Subject: Dresden Units 2 and 3  
Status of DCRDR Modifications  
NRC Docket Nos. 50-237 and 50-249

## DCRDR STATUS AFTER UNIT 3 SECOND REFUEL OUTAGE (D3R11)

CEILING LAYOUT OVER 902-4 PANEL

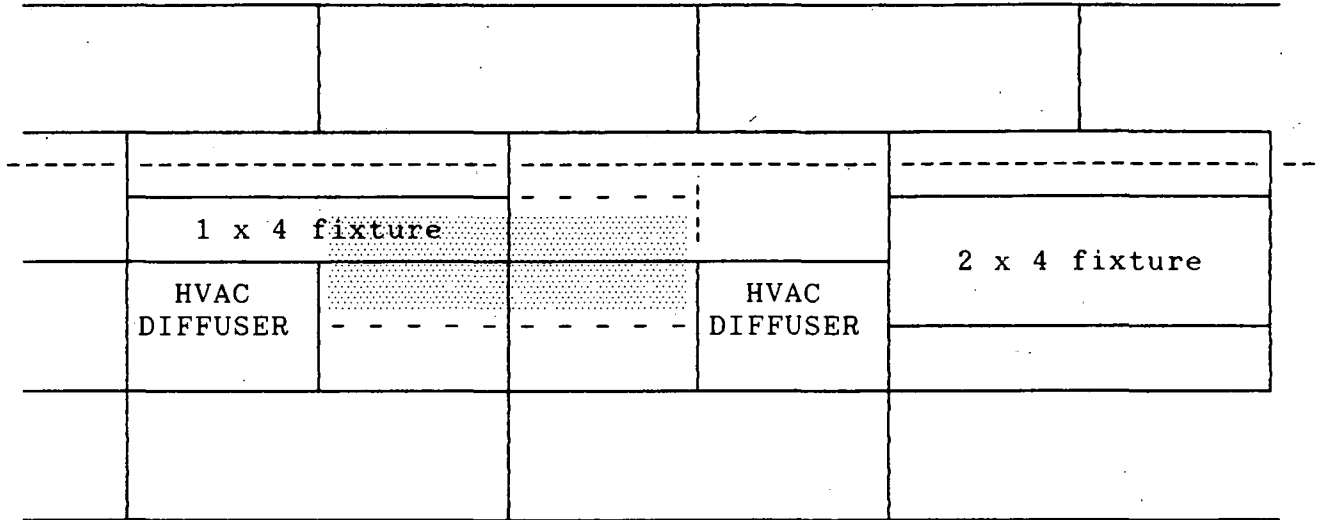
The 902-4 panel deviates from the criteria of twenty footcandles as the minimum illumination level in the control room. The current levels average 13.75 footcandles at the top row of meters. The 903-4 panel meets this criteria. The basis for the deviation is the position of an HVAC diffuser in the ceiling. The diffuser, related duct work, and support structure compelled the lighting consultant to install a 1 ft by 4 ft lighting fixture over the 902-4 panel. See attached figure. This fixture is one-half of the width of other fixtures used over the rest of the main control room panels. The 1 x 4 fixture will be replaced with a 2 x 4 ft fixture, if interferences can be reposition - or replaced by incandescent lighting. Either solution is expected to increase the amount of light falling on the 902-4 panel to satisfy the HED. The addition of the 2 x 4 ft fixture will make the lighting fixtures in the ceiling over Unit 2 identical to the configuration used over Unit 3.

After review by Nuclear Engineering it was decided that a new 4 bulb fixture will replace the present 2 bulb fixture. This fixture needs to be special ordered and is estimated to take 4 months for delivery. Engineering will also need to revise the structural supports of the ceiling in order to accommodate installation of the fixture. It is estimated that this work will be completed by the end of July 1990.
